United States Patent and Trademark Office

Application No.	Applicant(s)				
	10/698,513	AZZOLINI, GRAZIANO				
Office Action Summary	Examiner	Art Unit				
	Leslie R. Deak	3761				
The MAILING DATE of this communication appears on the cover sheet with the correspondence address Period for Reply						
A SHORTENED STATUTORY PERIOD FOR REPLY WHICHEVER IS LONGER, FROM THE MAILING DA - Extensions of time may be available under the provisions of 37 CFR 1.13 after SIX (6) MONTHS from the mailing date of this communication. - If NO period for reply is specified above, the maximum statutory period was reply received by the Office later than three months after the mailing earned patent term adjustment. See 37 CFR 1.704(b).	ATE OF THIS COMMUNICATION 36(a). In no event, however, may a reply be tirr vill apply and will expire SIX (6) MONTHS from cause the application to become ABANDONE	N. nely filed the mailing date of this communication. D (35 U.S.C. § 133).

DETAILED ACTION

FIG. I

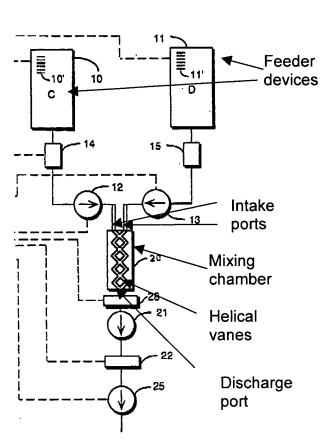
2. Claim 1 is rejected under 35 U.S.C. 102(b) as being anticipated by US 5,569,181 to Heilman et al.

In the specification and figures, Heilman discloses a fluid delivery system with a mixing unit 20 with two intake ports that are connected to feeders 10, 11, a discharge port that is capable of being connected to an outflow device, wherein the mixing unit comprises a hollow body with static helical mixing vanes therein in order to allow the mixing and passage of fluid therethrough. See FIG 1, column 3, lines 45-67) and FIG reproduced below.
